**Re: 1299 Beacon Street Brookline, MA, Updated Drawings, and Construction Management Plan**

Reference: Traffic Study Peer Review **MEMO #3**  
Chapter 40B, 1299 Beacon Street  
Zoning District G-1.75, Precinct 10

Figure 2-10. Minimum Turning Path for Passenger Car (P) Design Vehicle

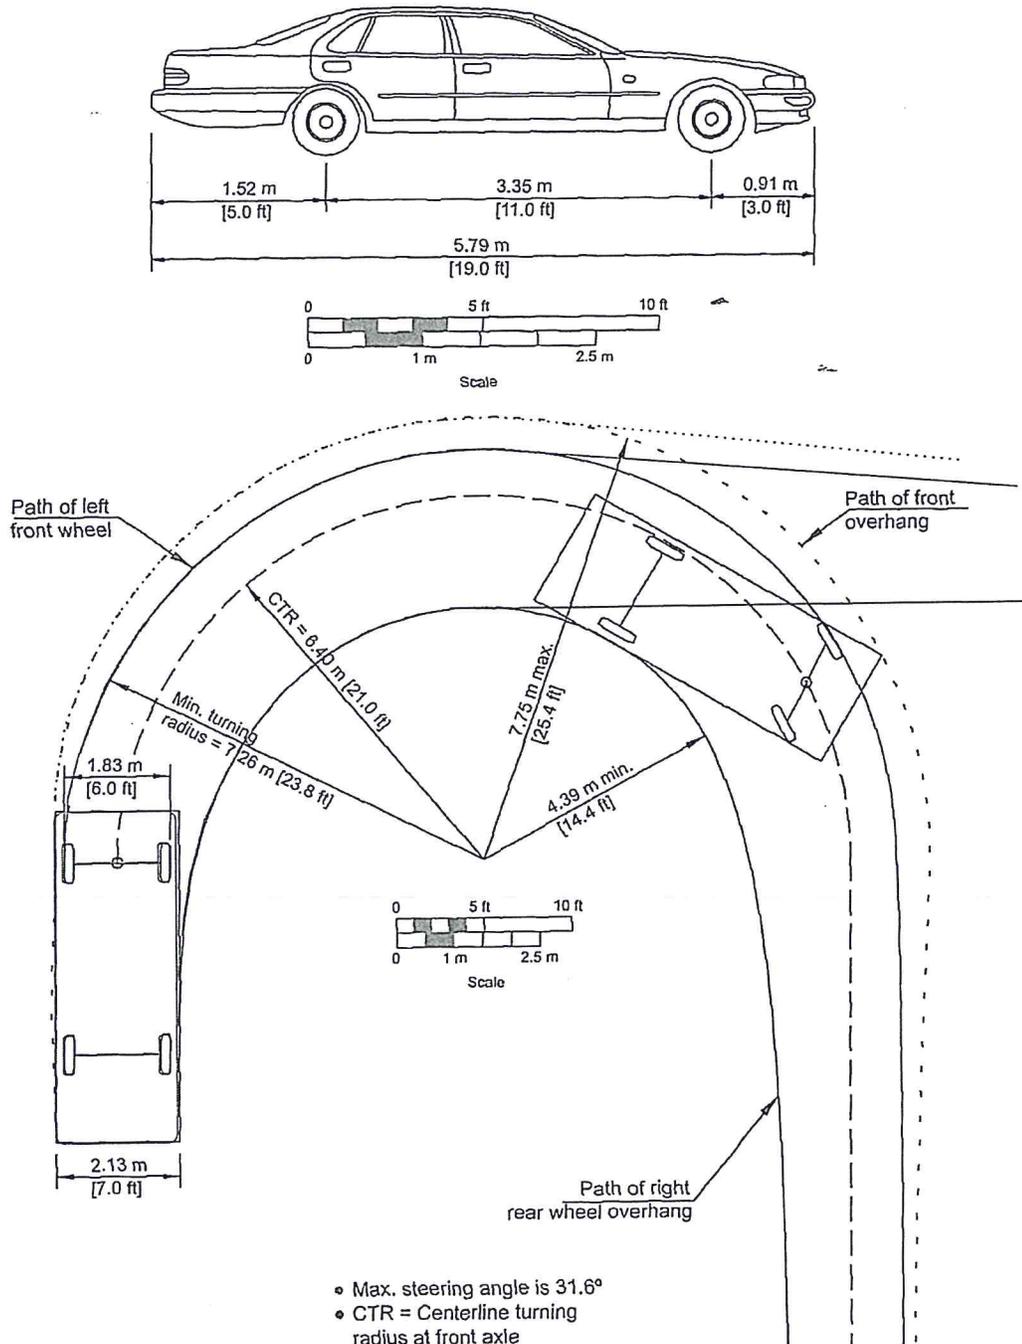
As seen in last years' American Association of State Highway and Transportation Officials [AASHTO] manual (A Policy on Geometric Design of Highways and Streets – 7<sup>th</sup> Edition 2018) the current design passenger car on Figure 2-10, is still seven-feet wide by 19 feet long. While some automobile models have gotten smaller, the larger SUV's are the best sellers.

The blue turn line on the ramp shows exiting vehicles maneuvering over the down aisle double yellow center line where sight distance is already an issue. The ramp center line radii appears to be about 20 ½ feet as compared to the AASHTO design vehicle having an outside overhang radii of about 25.4 feet for vehicles leaving level P2 up the ramp to street level.
